150 Richmond Street Revised Concept Plan Summary

I-195 Redevelopment District Commission Meeting
November 9, 2022

Revised Concept Plan Submission

Program: 212,000 sf lab, anchored by RISHL

Site Plan Revisions

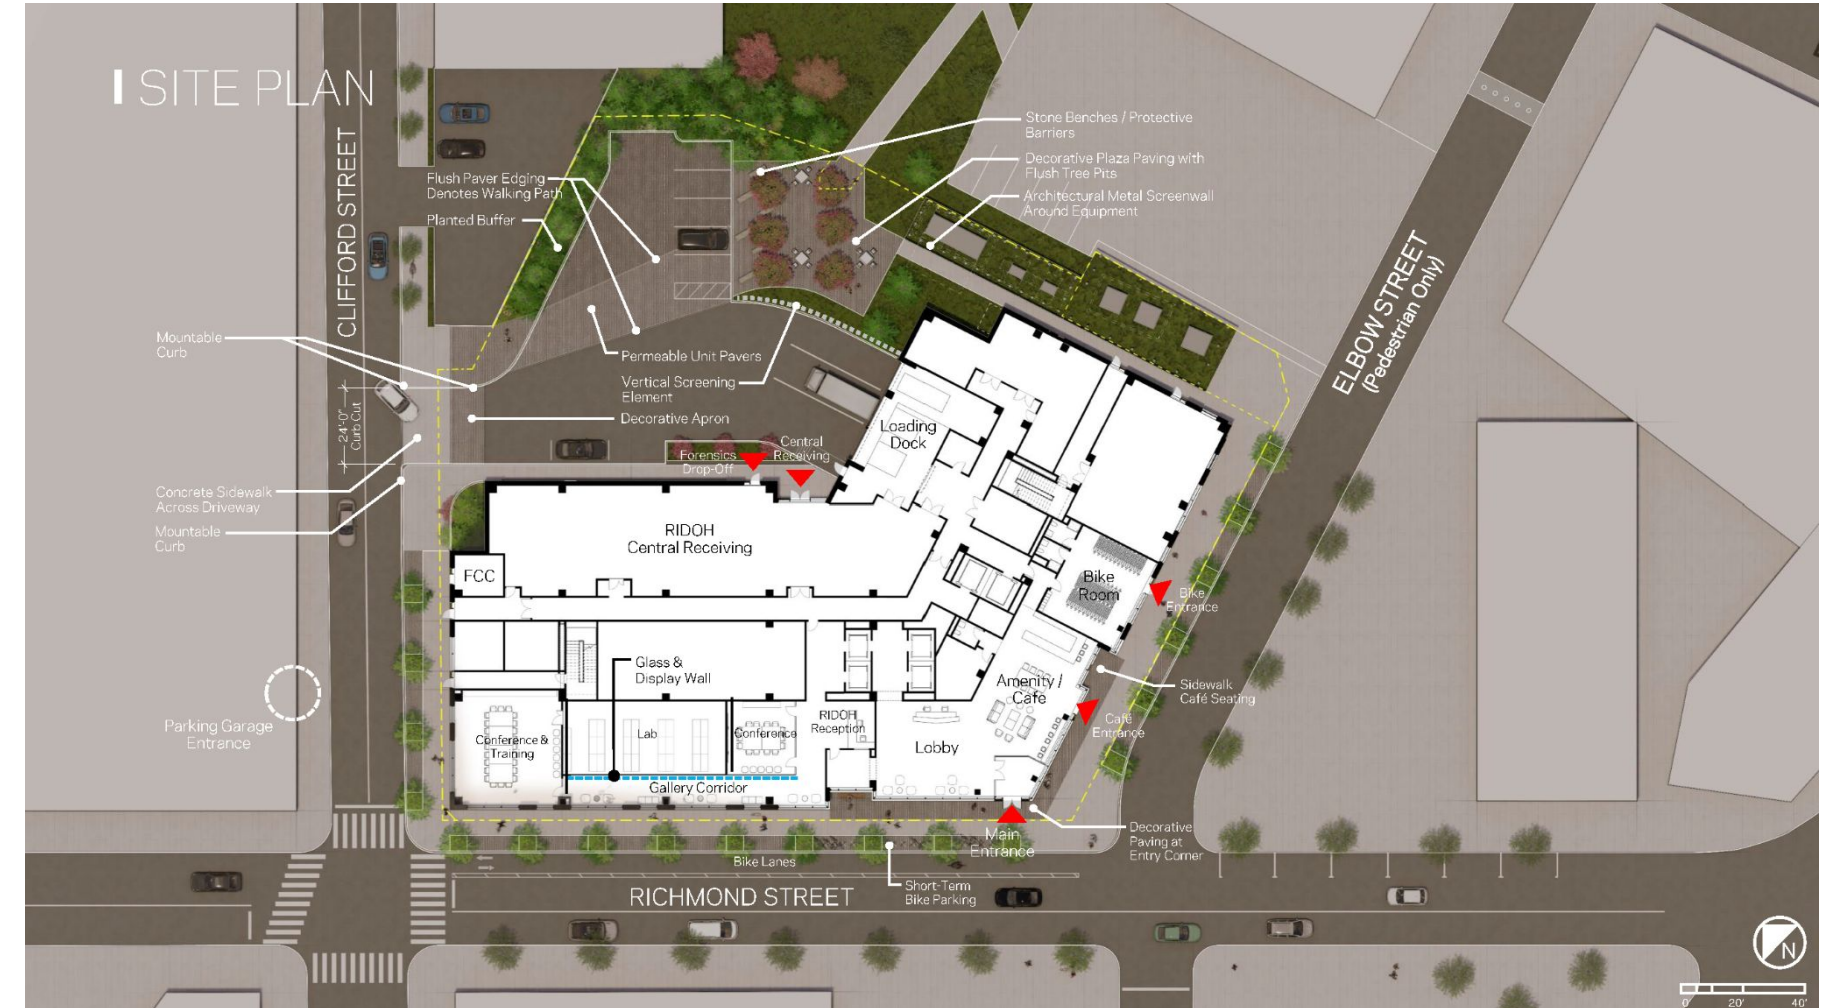
- Pedestrian circulation is not adequately prioritized in the site plan, especially in rear of building.
- Loading and surface parking solutions require further study because of the large curb cut and lack of adequate screening.

- Relocation of the bike parking into the building along Elbow Street opened up options to better solve the vehicular/pedestrian conflicts behind the building, but there is still more work to do to improve the connection from the mid-block pedestrian path to Clifford Street.

Revised Site Plan Circulation Approach

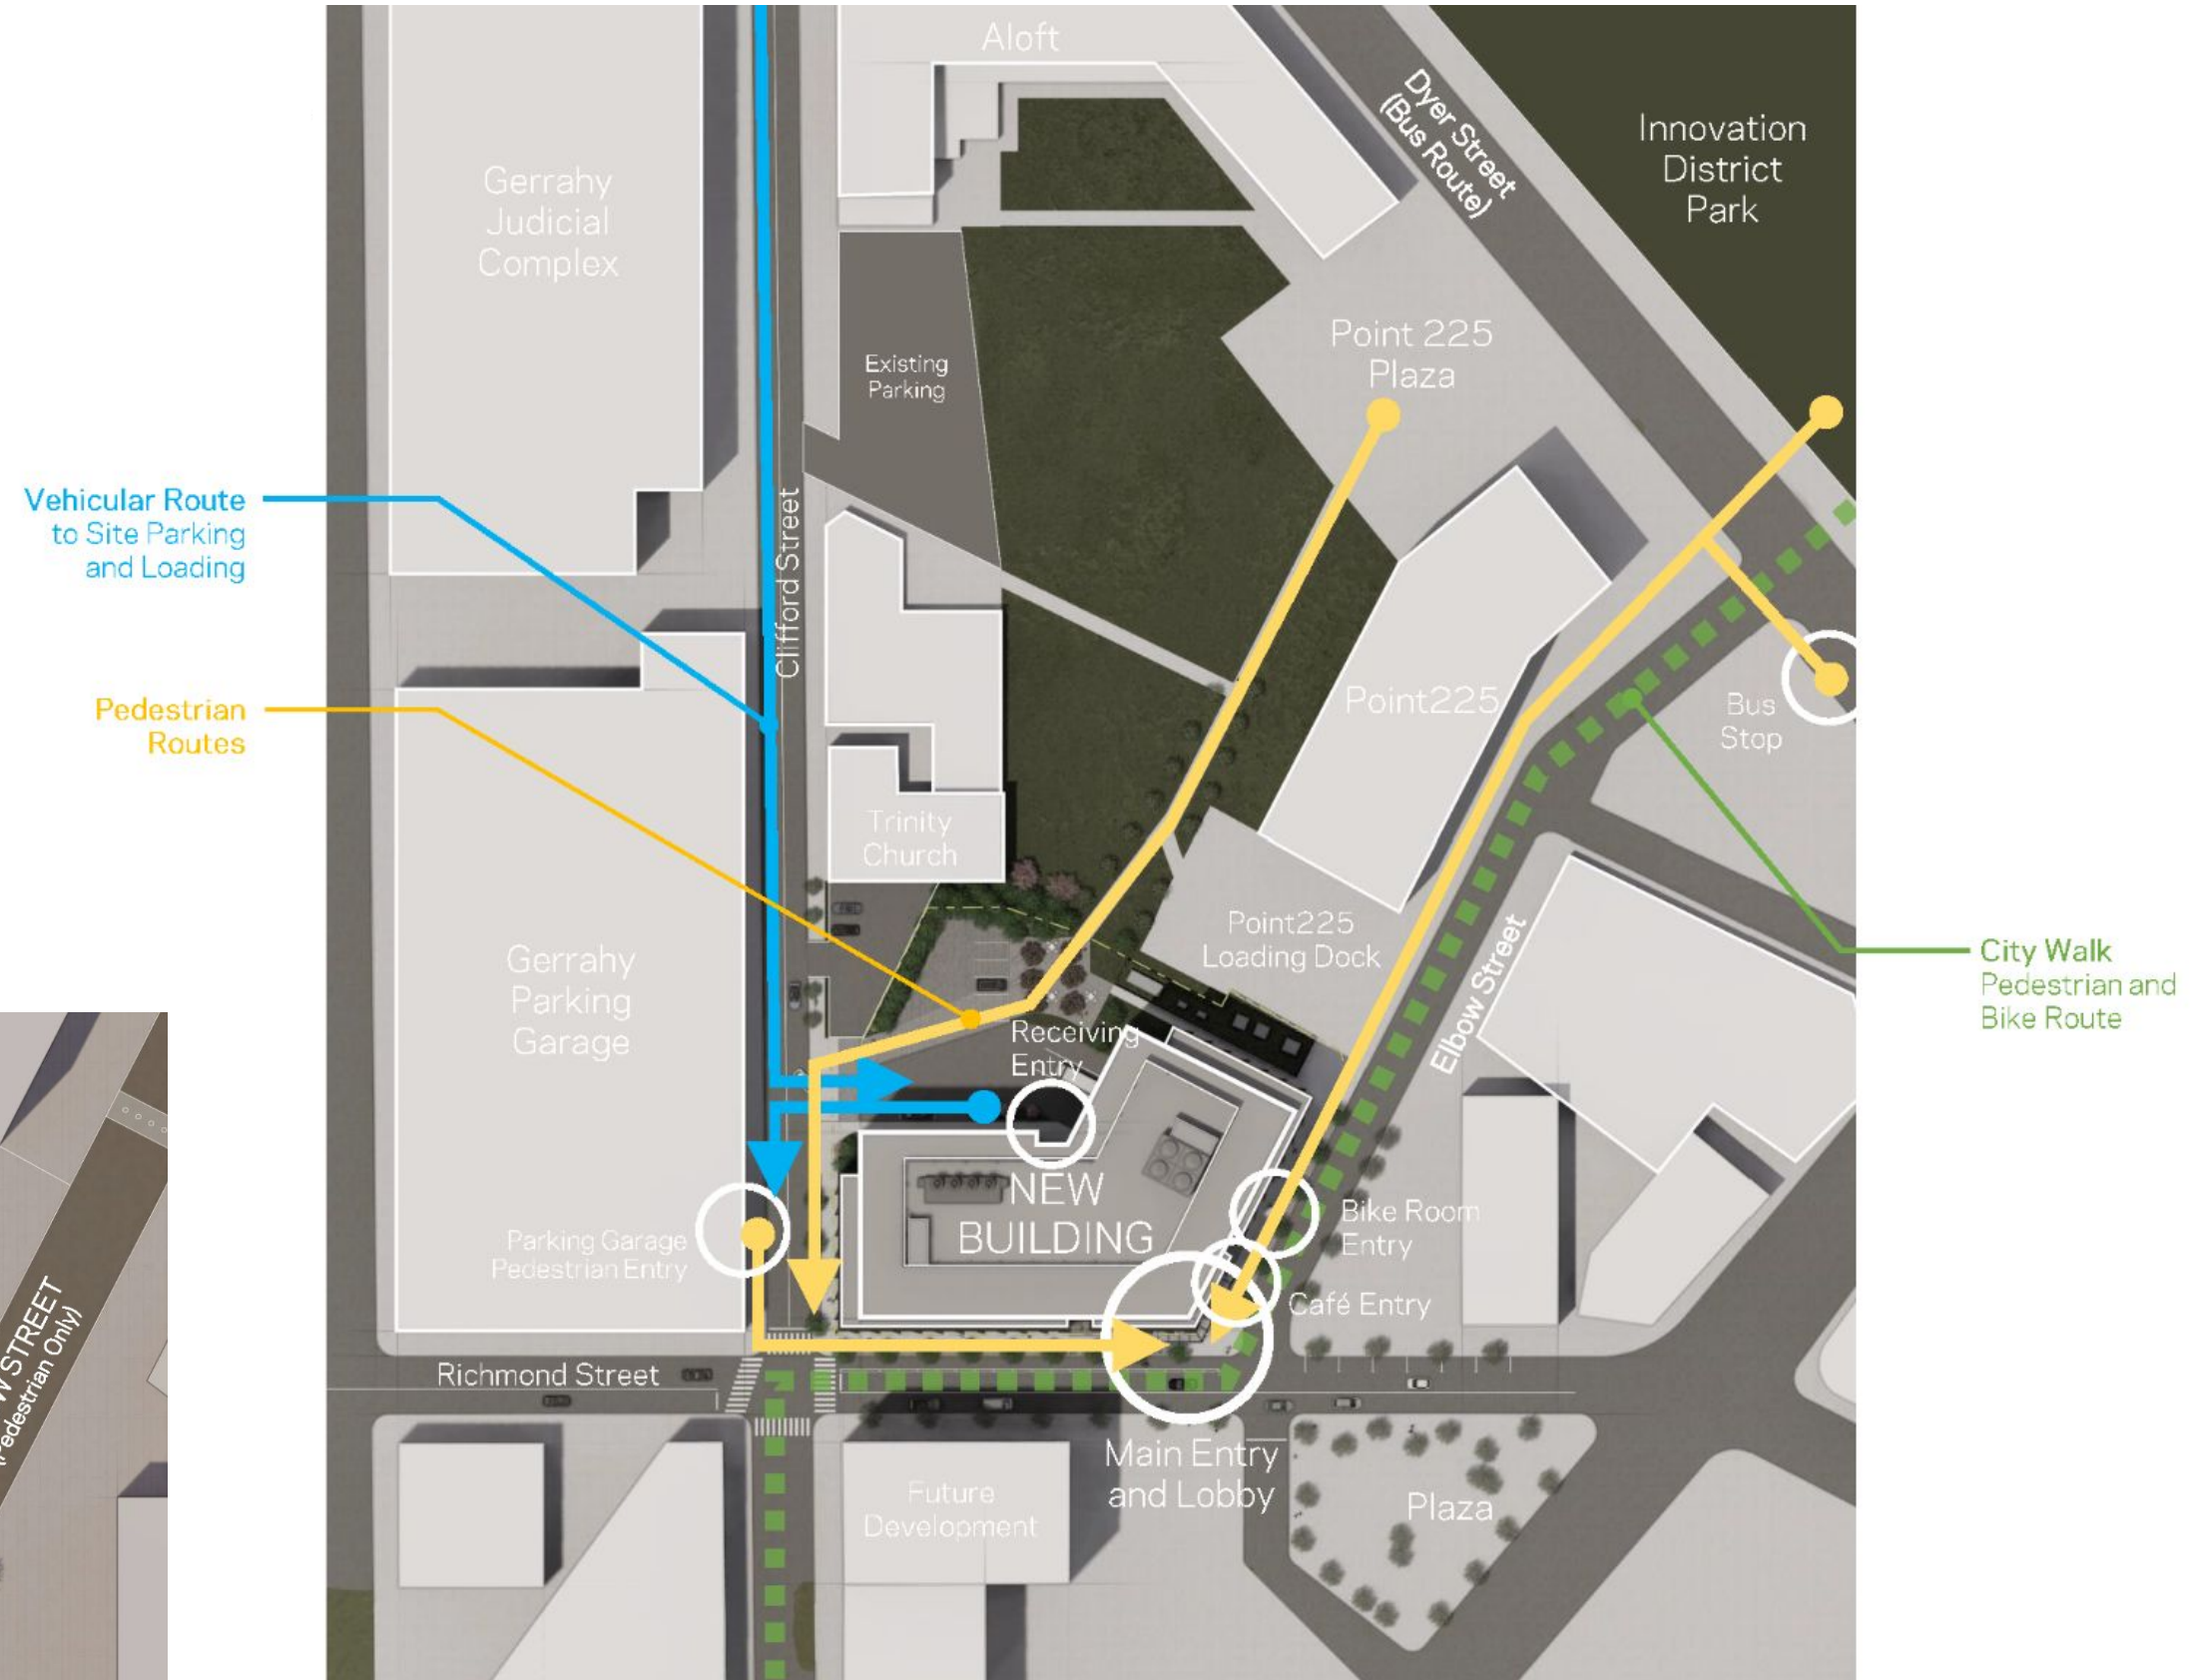
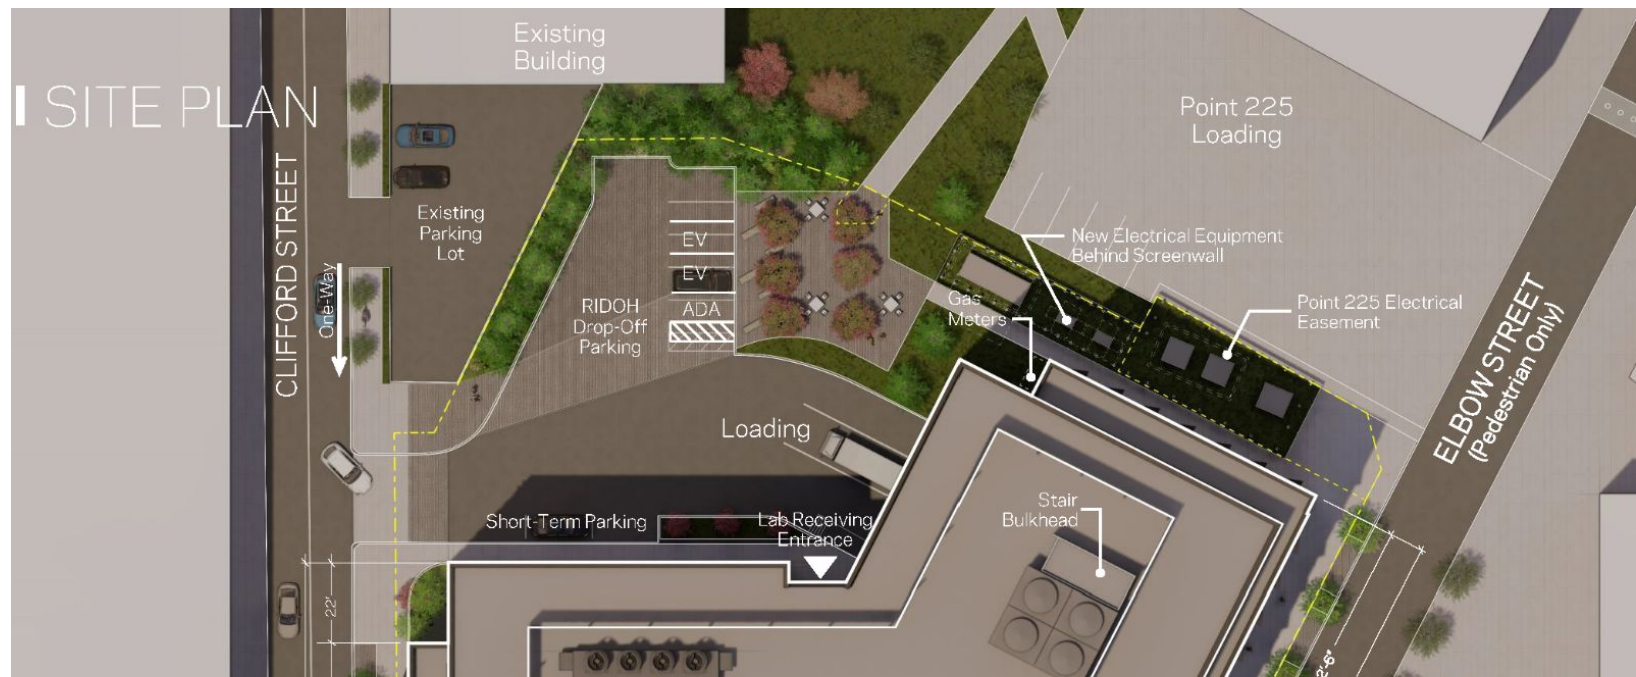
- Pedestrian circulation is not adequately prioritized in the site plan, especially in rear of building.
- Loading and surface parking solutions require further study because of the large curb cut and lack of adequate screening.

- **Relocation of the bike parking into the building along Elbow Street opened up options to better solve the vehicular/pedestrian conflicts behind the building, but there is still more work to do to improve the connection from the mid-block pedestrian path to Clifford Street.**

Ground Floor Plan

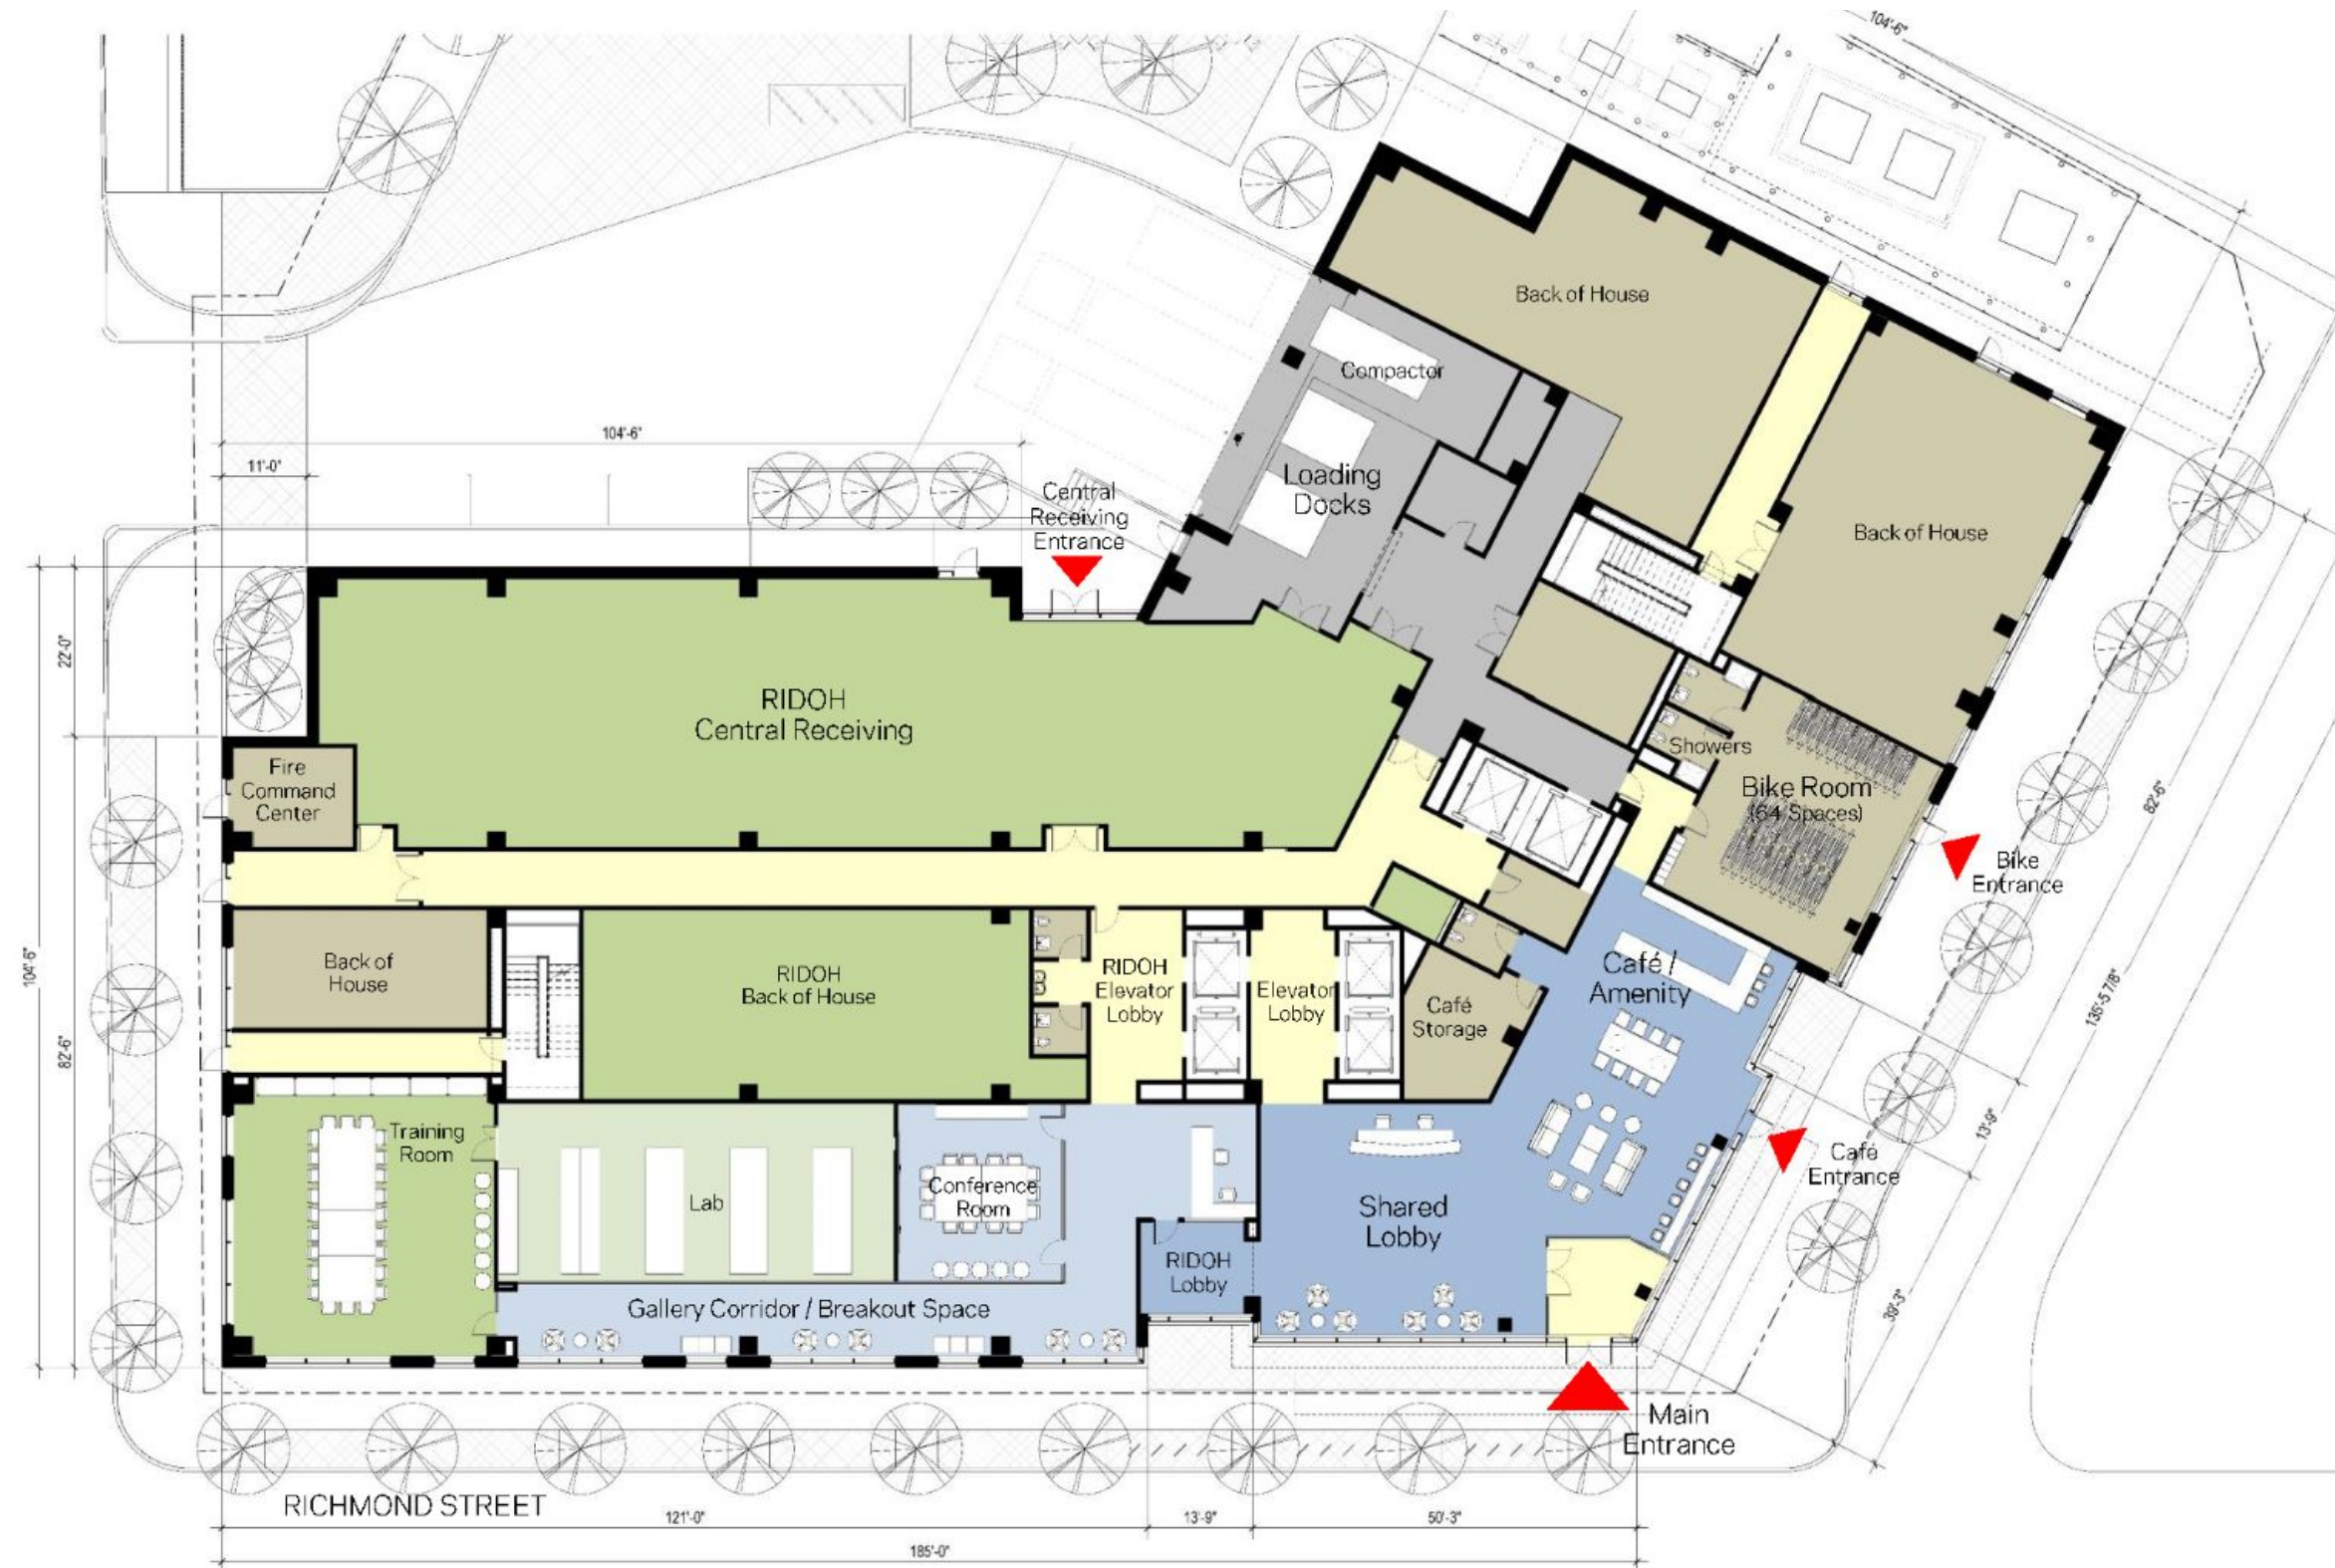
- Explore the possibility of separate front doors for RIDOH and/or the retail/amenity space, in order to more fully activate the public realm, especially along Richmond Street.
- Explore the introduction of more entryways to order to activate the street frontage.
- The Elbow Street frontage is mostly back-of-house spaces. Add interior bike parking to that edge to help activate the sidewalk.

- **Improvements to the ground floor plan include:**
 - **Enclosed bike room with direct connection to lobby/cafe/amenity space**
 - **Dedicated second door to the cafe/amenity space**
